Title		
DP139 HDMI EVM Revision History		
Size	Document Number	Rev
A	xxxxxxx	A
Date: Saturday, March 07, 2009		
Sheet 1 of 1

PAGE TITLE SOURCE SIDE			
SIZE	DOCUMENT NUMBER	REV	PAGE
A	6506501	A	2 of 5

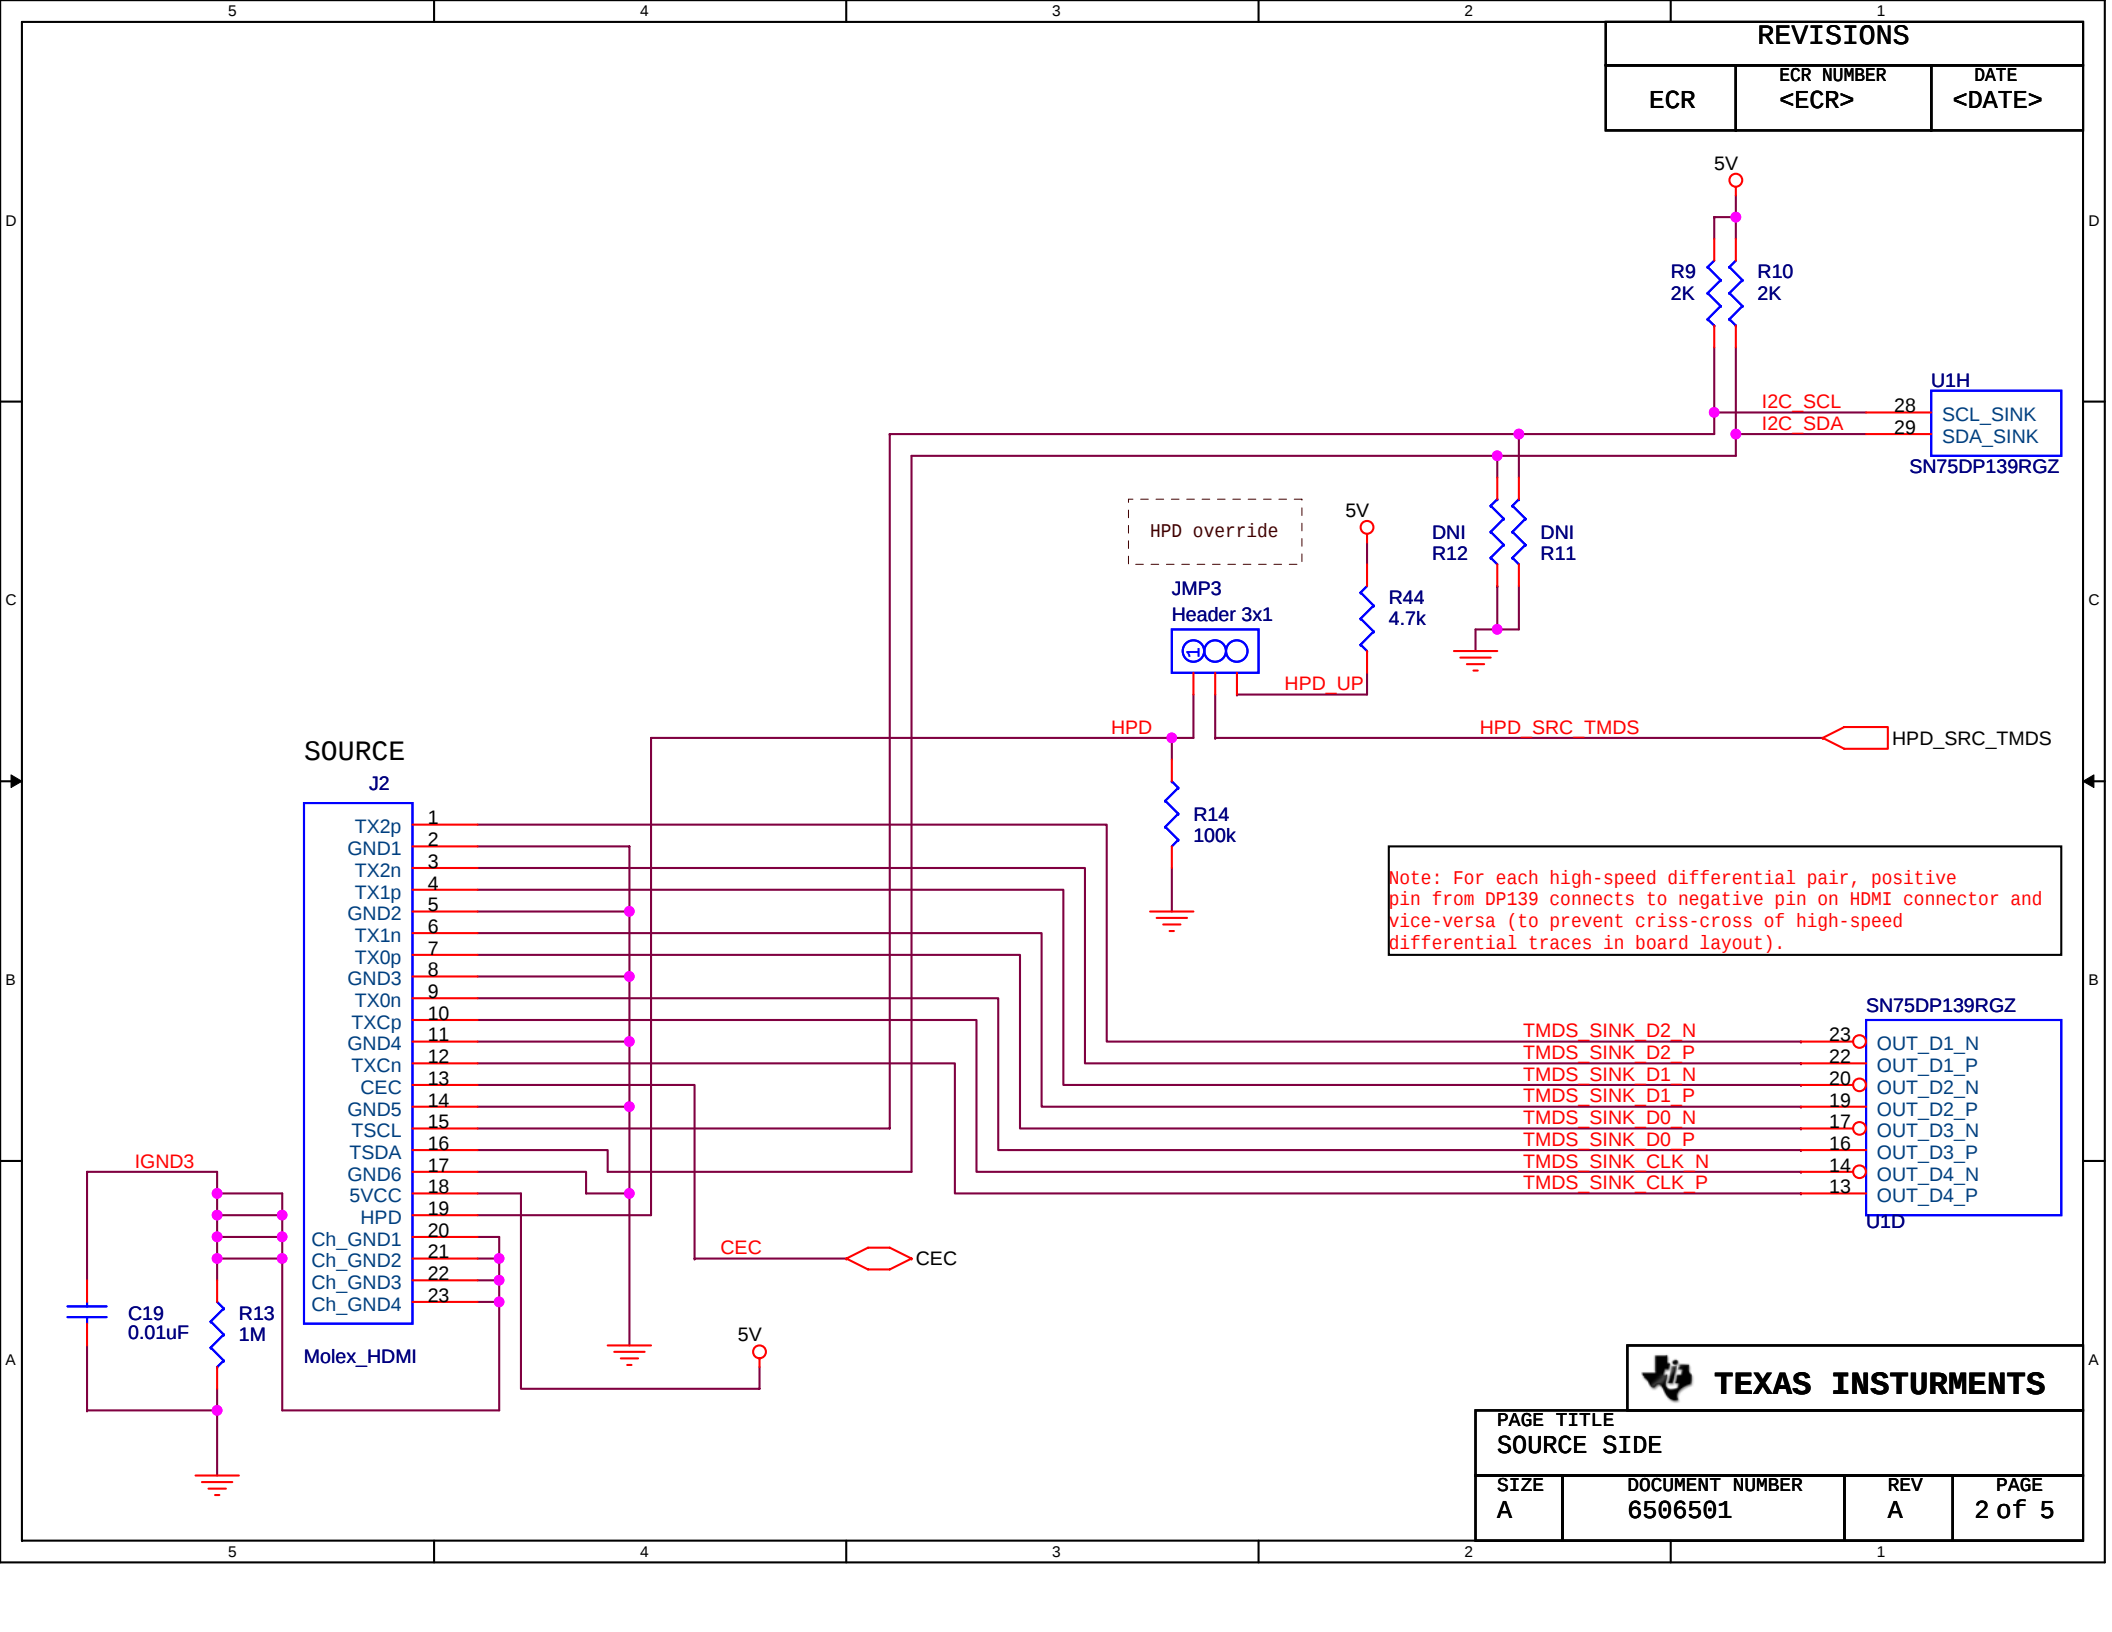
Rev B: Corrected connections between HDMI connector and DP139 TMDs outputs 03/07/09
Changed VSadj to 4.02k based on datasheet revision 0.4 03/07/09

Note: For each high-speed differential pair, positive pin from DP139 connects to negative pin on HDMI connector and vice-versa (to prevent criss-cross of high-speed differential traces in board layout).
